Metropolitan Historic Zoning Commission
Sunnyside in Sevier Park
3000 Granny White Pike
Nashville, Tennessee 37204
Telephone: (615) 862-7970
Fax: (615) 862-7974

STAFF RECOMMENDATION 2509 West Linden Avenue September 18, 2019

Application: New Construction—Addition
District: Hillsboro-West End Neighborhood Conservation Zoning Overlay
Council District: 18
Map and Parcel Number: 10415031100
Applicant: Leslie Ammons, Allard-Ward Architects
Project Lead: Sean Alexander, sean.alexander@nashville.gov

Site Plan

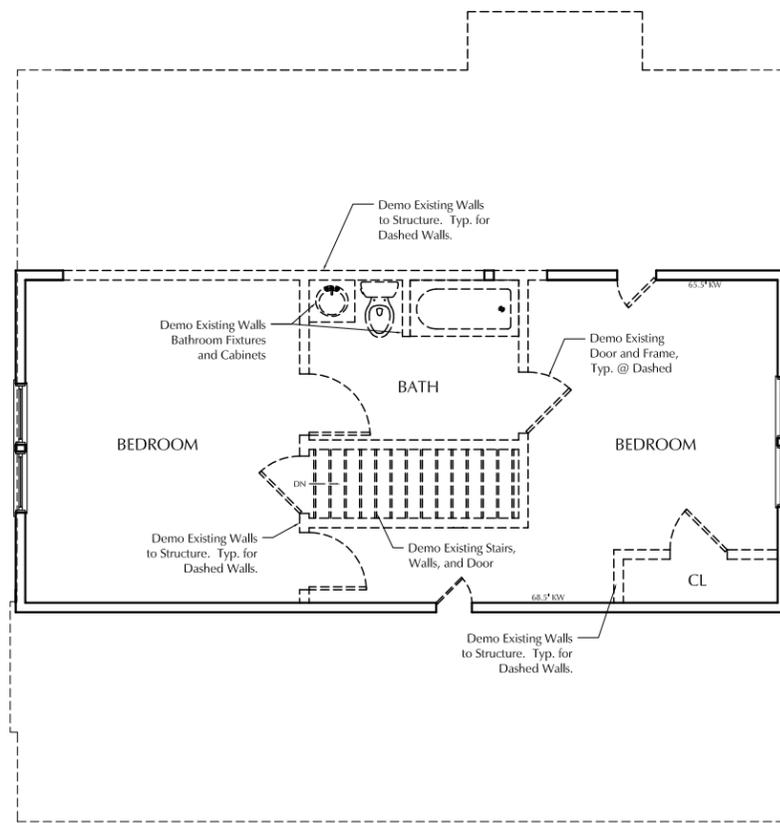
Setback & Rhythm of Spacing: The addition steps in from the right side of the house and will have a right side setback of five feet (5'). Although the addition is wider than the primary mass of the building to the left, it does not extend beyond the edge of the original side porch. Because the wider carport component is so far back from the front, and only wider in the partial basement-level carport, staff finds that the addition will not impact the perceived rhythm of spacing of buildings along the street.

Staff finds that the setbacks of the project are appropriate and meet section II.B.1.c of the design guidelines.

Drawings:
 Demolition Plans
 Date:
 08.30.19

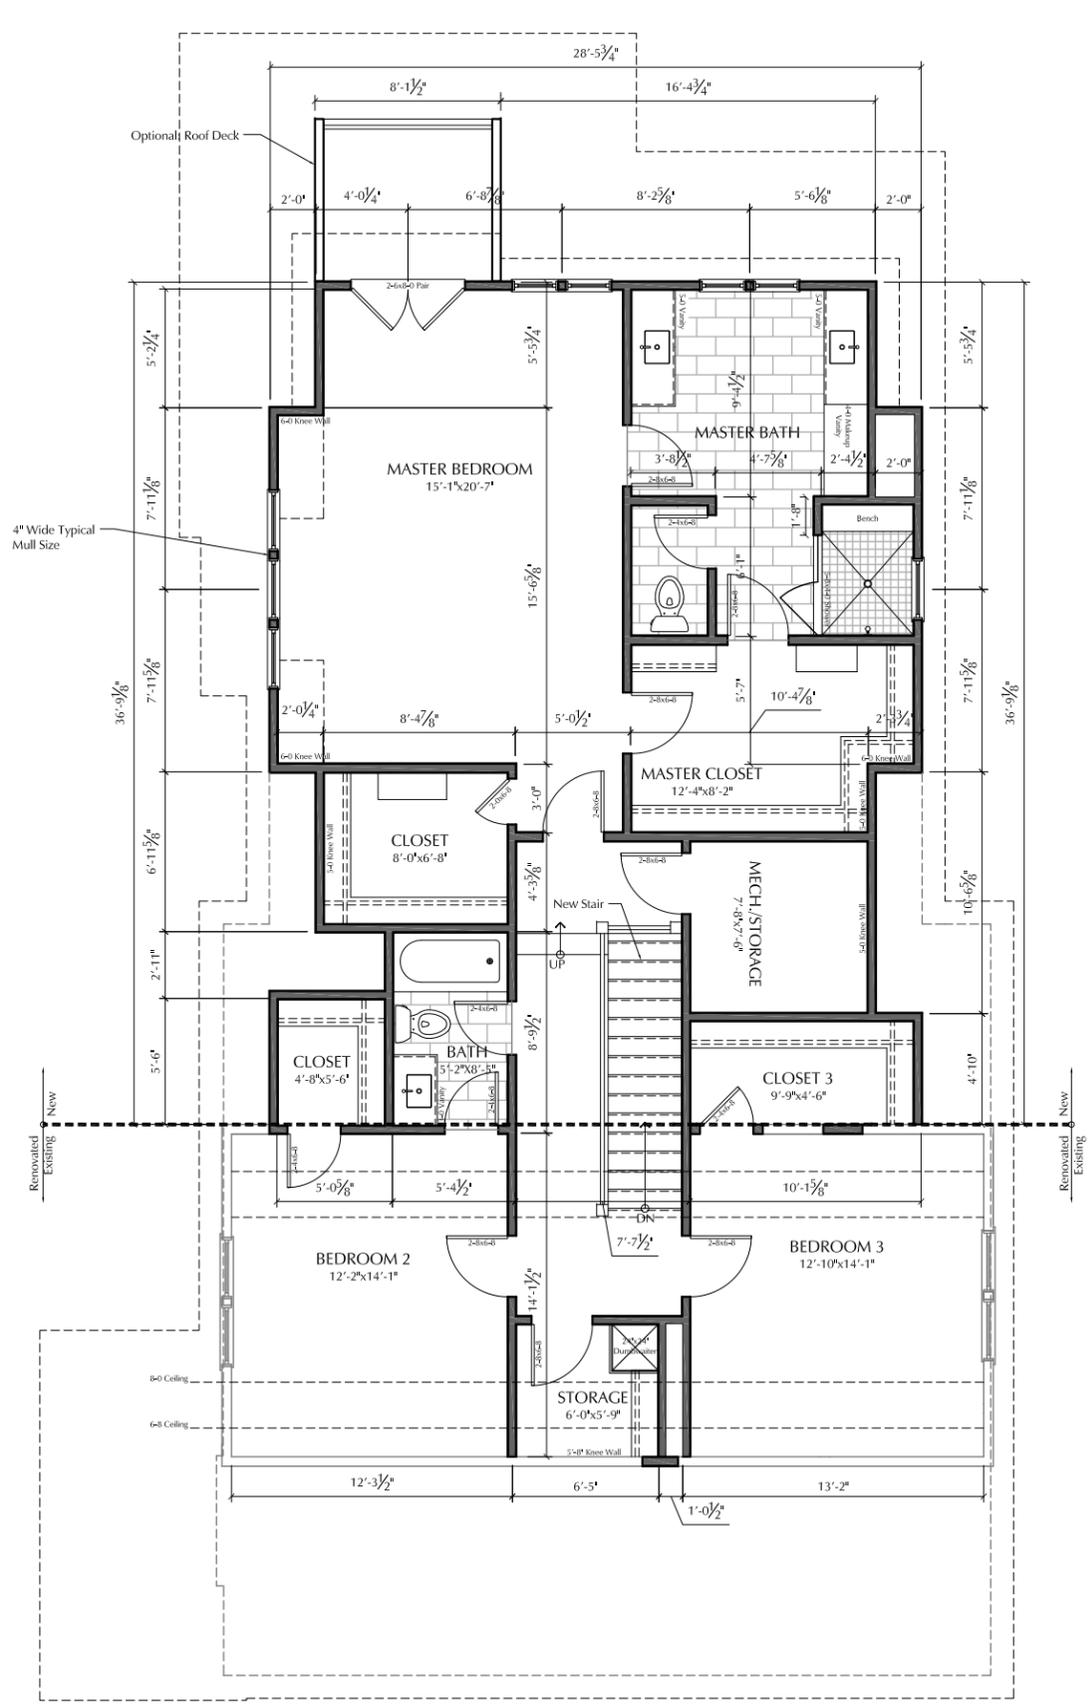
Demolition: Portions of the rear of the building and an existing rear deck will be demolished to accommodate the new addition. The plans indicate that windows on the

left side of the historic house will be replaced, but that the location and sizes do not appear to be changing. The addition will not otherwise impact the front or sides of the historic house. The portions being removed are not significant to the historic character of the house.

Staff finds the partial demolition to be appropriate and to meet section III.B.2.b of the design guidelines.

Drawings:
 Floor Plans
 Date:
 08.30.19

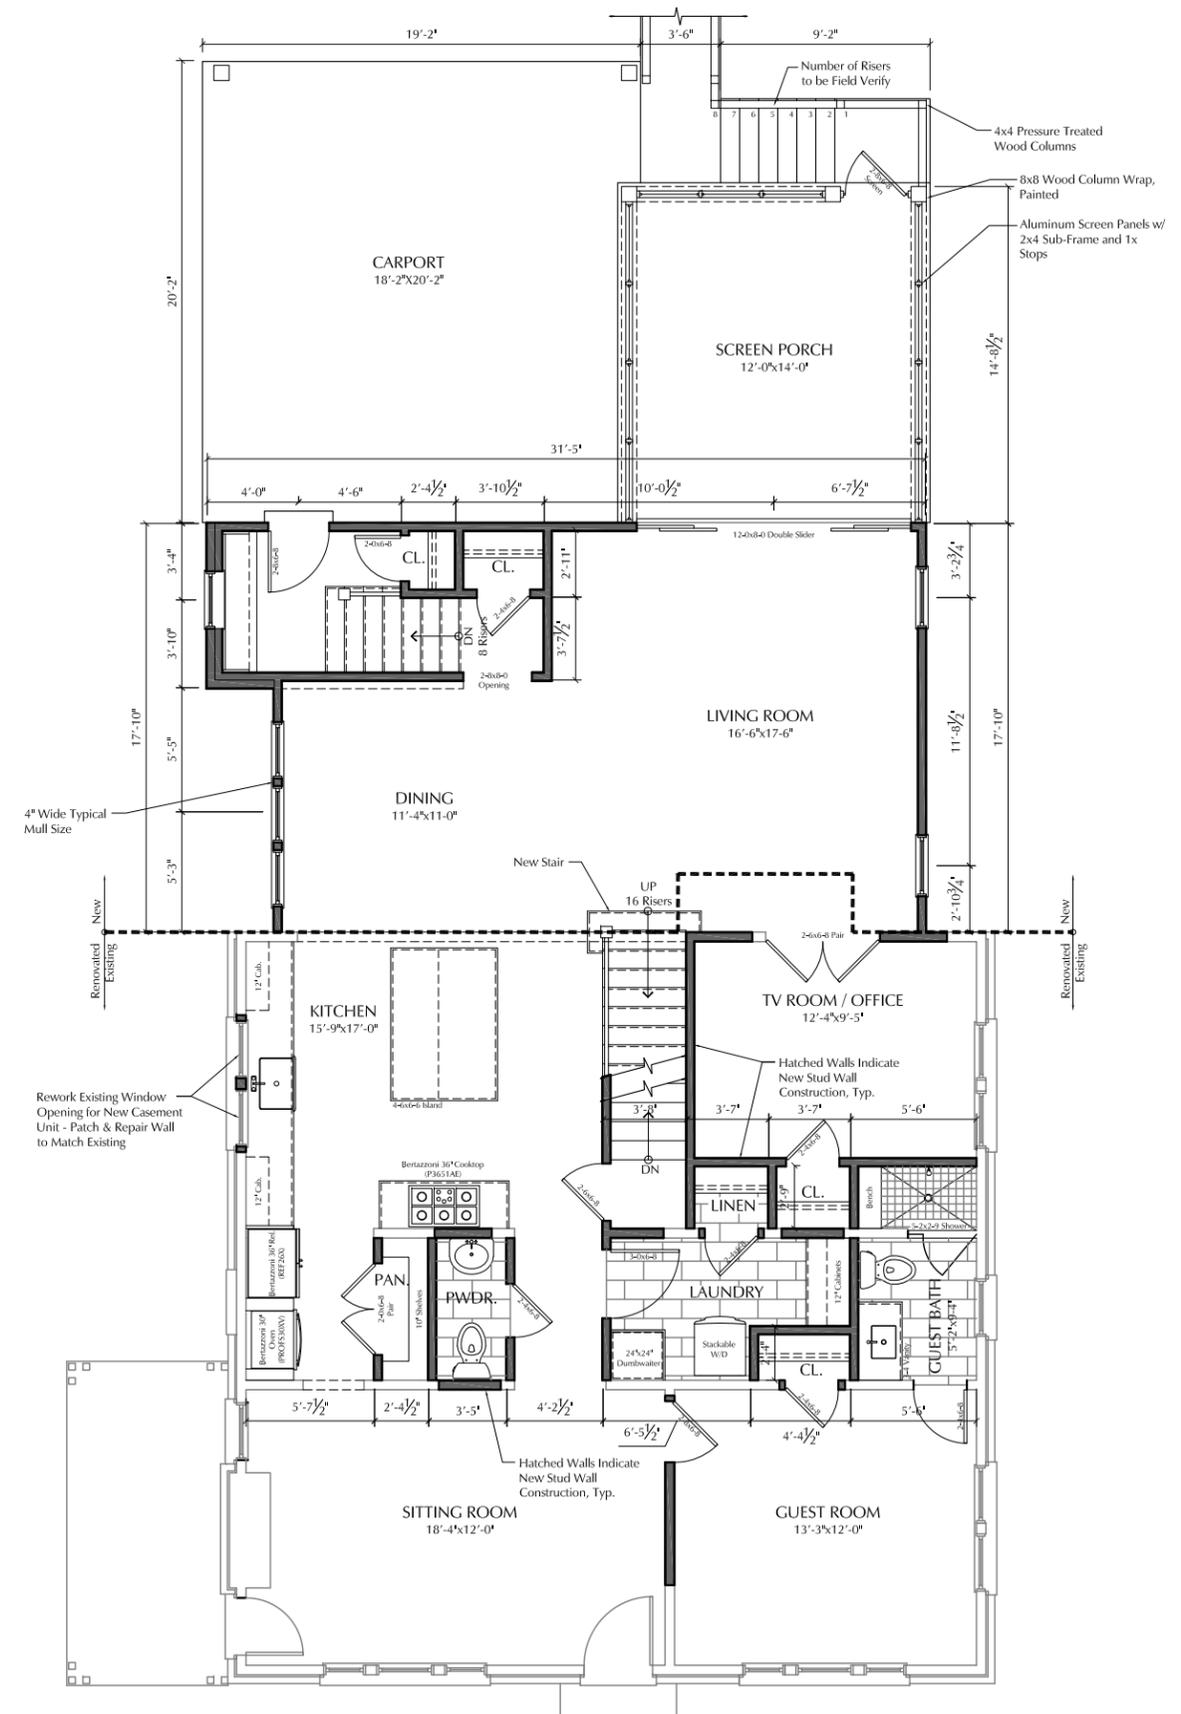
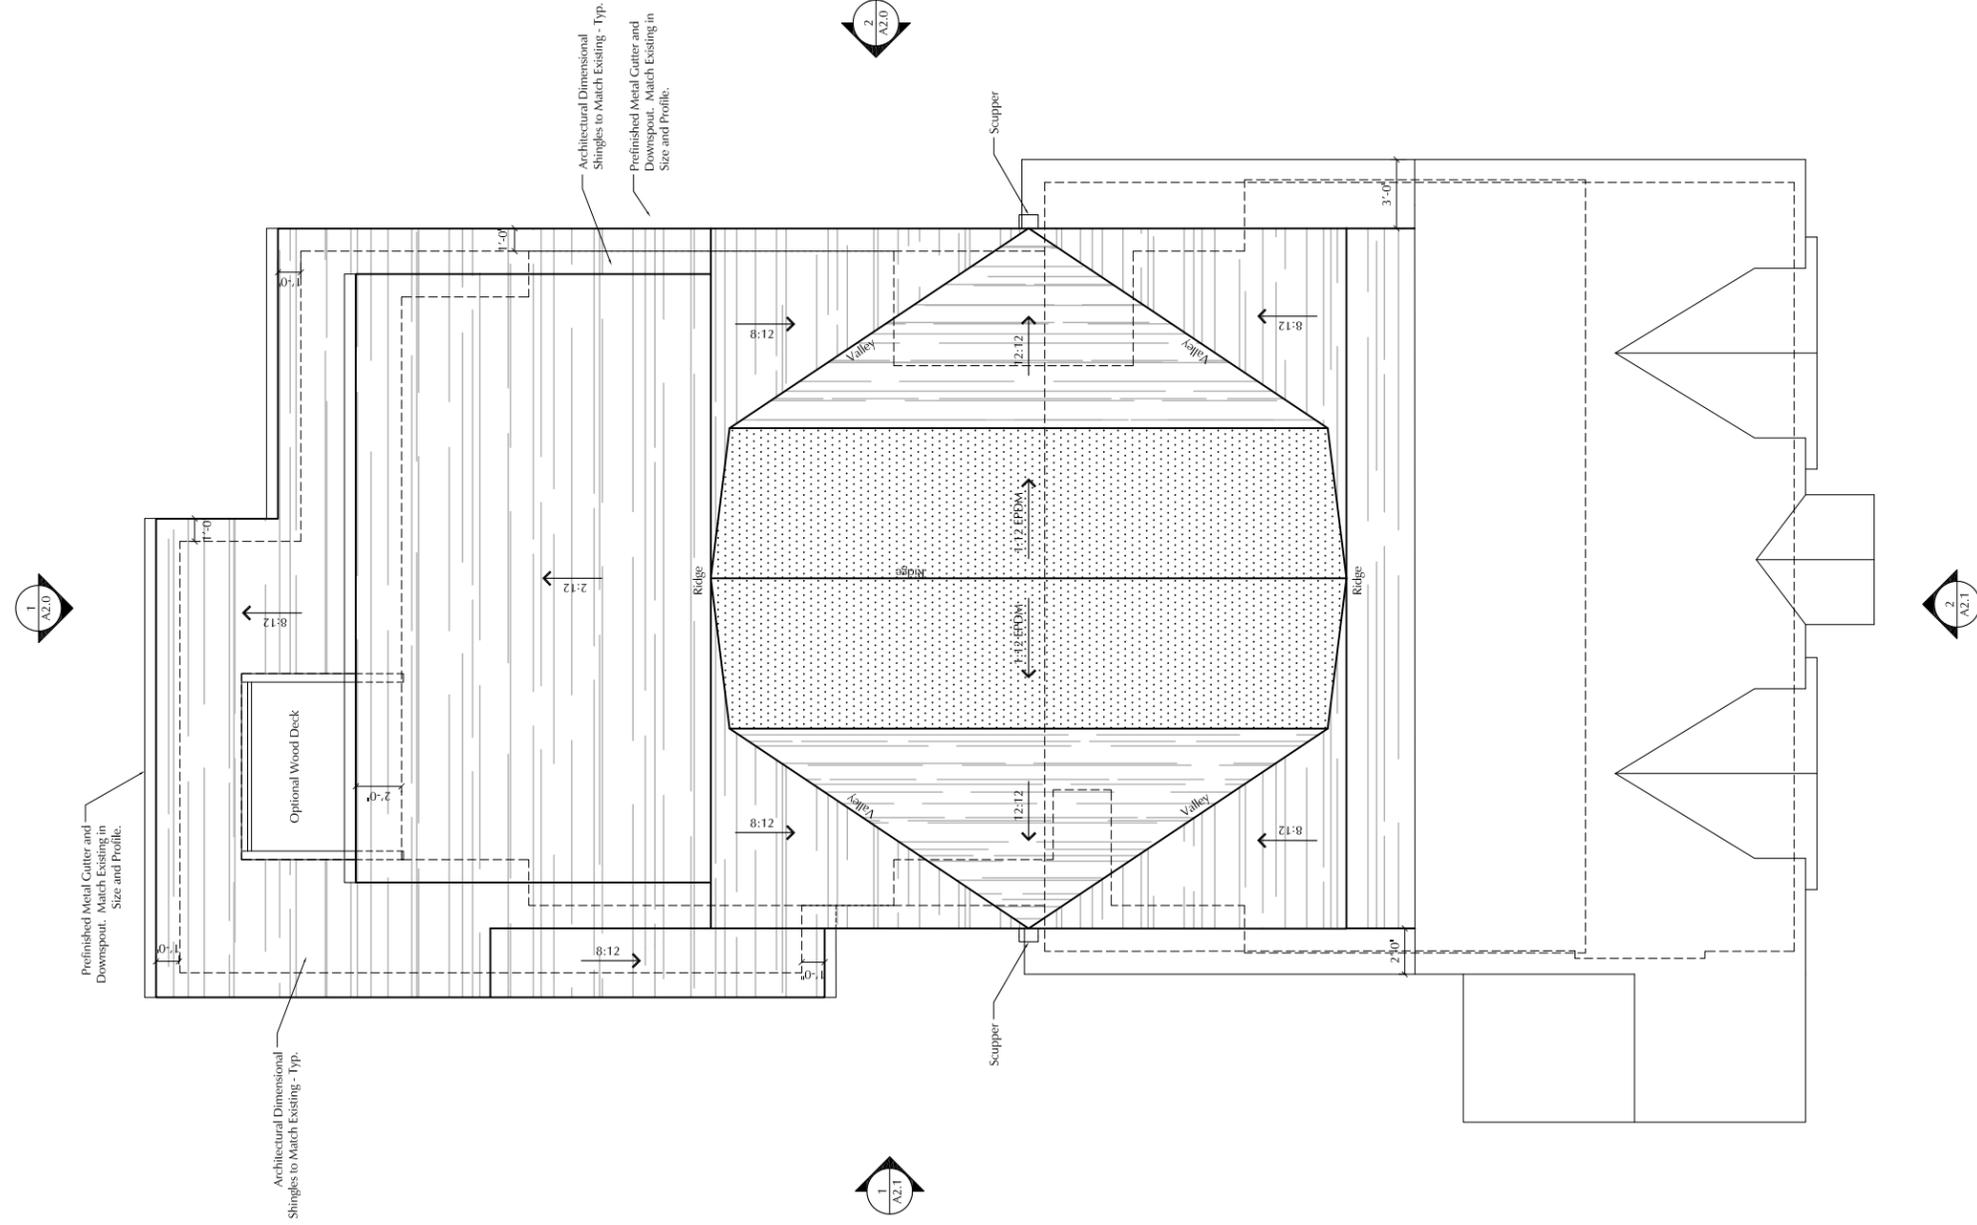
The walls of the addition will attach to the existing house at the rear of the building, stepped in two feet (2') from the left side wall of the house and three feet (3') from the right before extending back. On the left side, the addition will extend back ten feet, eight inches (10'-8"), then the first story will step back out three feet (3') to the left, which puts the edge of the addition one foot (1') wider than the primary mass of the building on that side. The upperstory on the left side will remain stepped in two feet (2') and the entirety of the right side will remain stepped in three feet (3') without stepping back out.

Typically, it is not appropriate for additions to be wider than an historic house, especially when that addition is also taller than the historic house. In the current proposal, while the addition steps out one foot (1') wider than the primary mass of the historic house on the left side, it does so only on the first story which will be behind and well inside the silhouette of an original side porch on the left side of the house.

The addition includes an attached carport in the rear, accessed from the side. Due to a drop in grade toward the rear of the lot, the carport floor is several feet lower than the main floor level. Attached parking is not typical of most streets in the neighborhood, but an intermittent stream crossing the lots on this block make putting a garage at the rear of the lot impracticable.

The depth of the addition will be thirty-seven feet (37'), which is four feet (4') greater than the depth of the historic house; however, the width of the addition is narrower than the historic house. Additionally, the rear twenty feet (20') of the addition will be relatively open because it comprises a screened porch and carport. Typically, additions should not more than double the footprint of an historic house, and the proposed total footprint will be approximately one hundred and fifty square feet (150 sq. ft.) less than that of the historic house.

Roof Plan

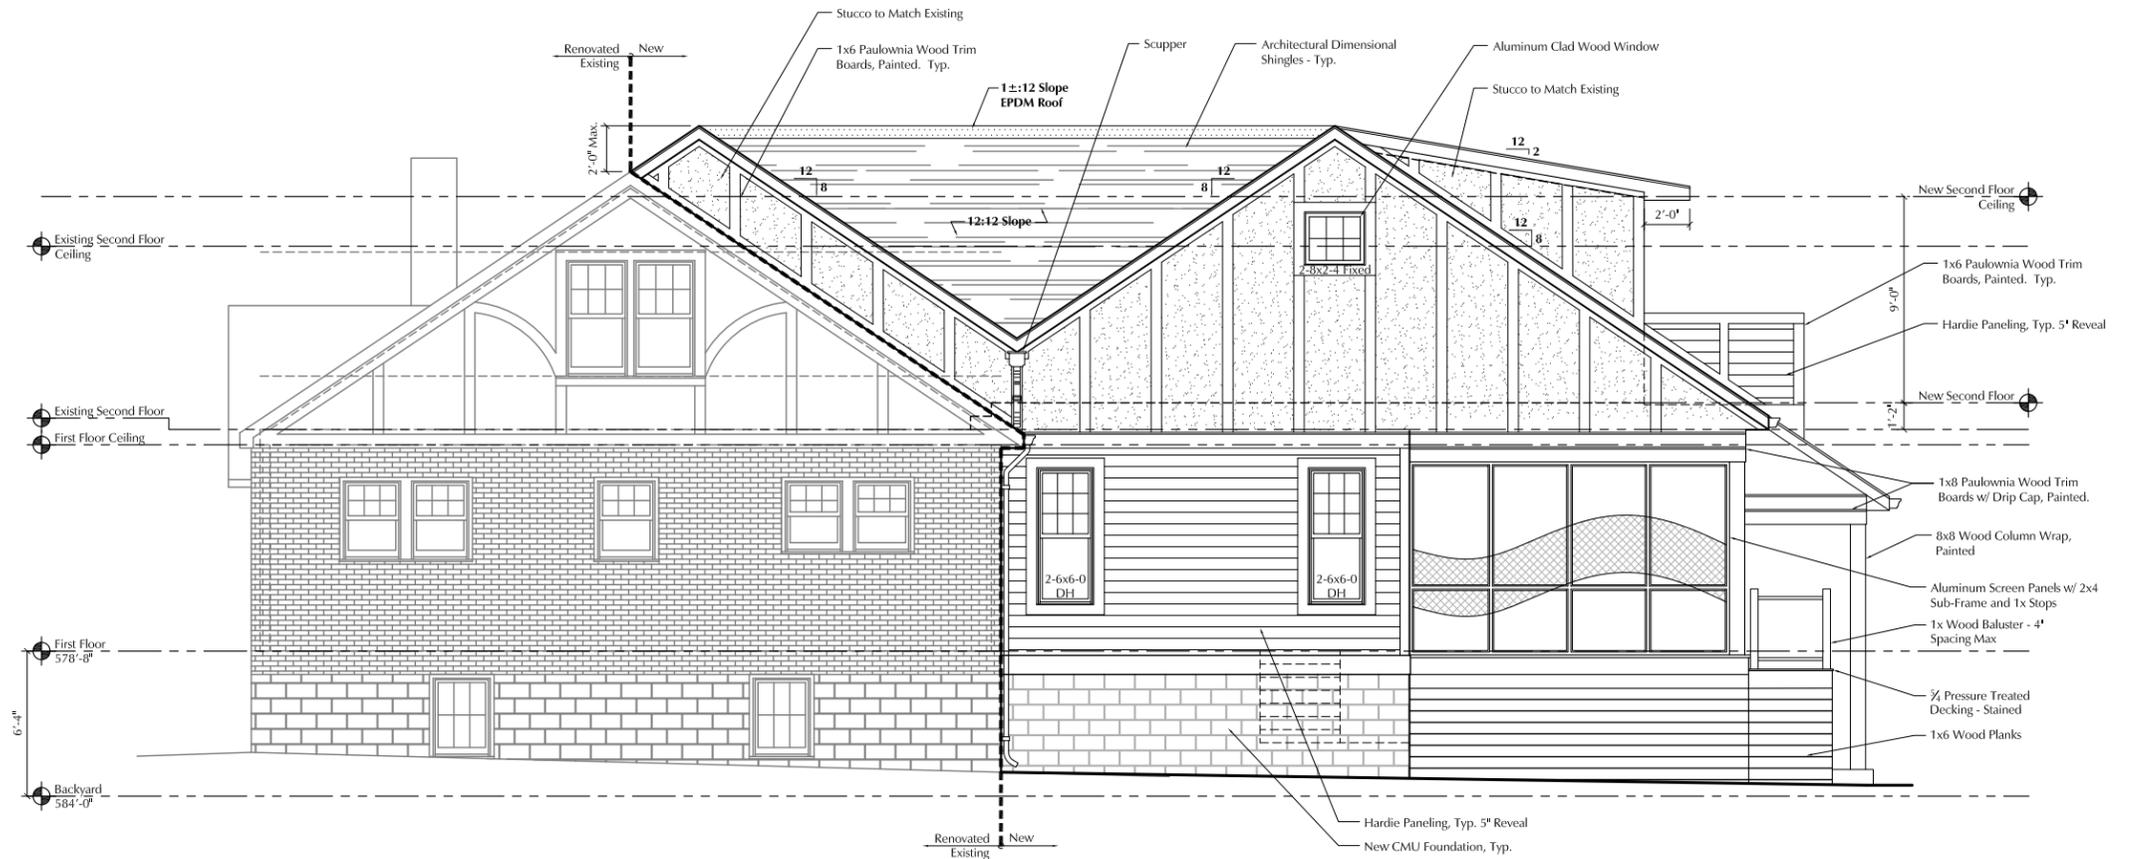
Location & Removability: The ridge of the house will be increased two feet (2') in elevation by extending the front slope of the gabled roof up and to the rear. Two feet (2') of the existing ridge on each side of the roof will remain unaltered to preserve an indication of the original form. This type of addition has been approved many times by the Commission to enable some one and one-half story homes houses to gain a more functional upperstory, without negatively impacting the historic integrity of the structure.

Roof form: The addition’s roof will have a side-gabled component, matching the 8/12 pitch and orientation of the historic house’s primary roof. A 12/12 ridged roof span will connect these two components. The roof on the carport component will be side-gabled to match the primary roof.

These roofs are compatible with those of the historic house and meet section II.B.1.e of the design guidelines.
